Replat #3
Hickory Woods
Medina Township

Meeting:	February 3, 2021	Site Area:	1.1113 acres
App. No.:	134-2020	Sublots:	1
Owners:	Robert Skiffey	Zoning:	U-R Urban Residential
Engineer:	Cornerstone Professional Land Surveyors Inc.	Utilities:	Central water and sewer
Parcel Nos.:	02606-D33-063 02606-D33-052	School Dist.:	Highland
		Reviewer:	Denise Testa

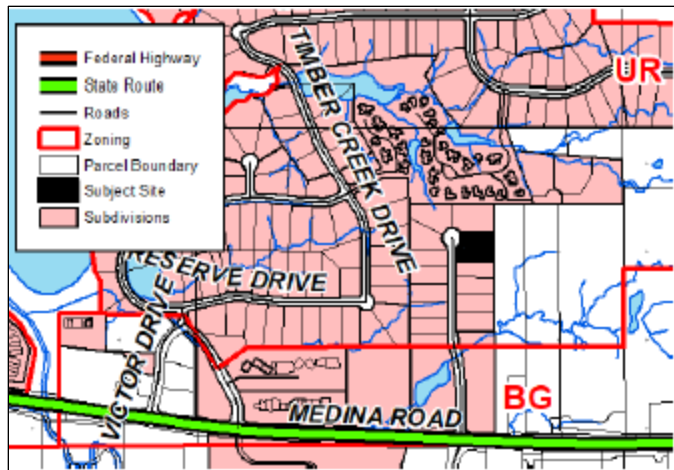
2. *I did find some correspondence stating that Block C should be part of sublots 5 or 6 from the original preliminary plan review. Our only thought through office discussions is that Block C may have been left open to access the rear portion of the parcel located to the east, as a large ravine bisects the parcel making SR18 access difficult. Just a thought, no documentation to back up the theory.*

It was the CPC's policy when there was substantial vacant land adjacent to a proposed subdivision to leave an access to that land. It doesn't appear that would be practical at this time so combining it with the adjacent lot would be beneficial.

1. Based on the existing information regarding the subdivision, we cannot determine the reason/purpose for the existence and location of Block C. Therefore, DPS concurs with the highway engineer that it is reasonable for the block to become part of Sublot 5.
2. Signature and seal of a Registered Surveyor on each sheet (§ 404(D)(2)f.16.). Provide signature and seal of a Registered Surveyor on each sheet.

3. Notarized certification by the owner or owners of the subdivision and the offer of the dedication of streets and other public areas and that there are no unpaid taxes or assessments against the land contained in the plat (§ 404(D)(2)f.17.). Provide notarized certification of the owner.
4. Certification from the Township that the Final Plat as submitted is in compliance with local zoning standards and requirements. Such Certification shall be in the form of an executed signature block on the original mylar and signed by at least two of the Township Trustees. (§ 404(D)(2)g.1.). Provide trustee's signatures.
5. Certification of County Engineer that all required improvements have been satisfactorily installed or financial guarantees have been provided to cover all construction. (§ 404(D)(2)g.5.). Provide Highway Engineer's signature.

Staff recommends that the **MCPC APPROVE WITH MODIFICATIONS** the Replat #3 of the Hickory Woods Subdivision subject to the following:

- Satisfy all staff comments.
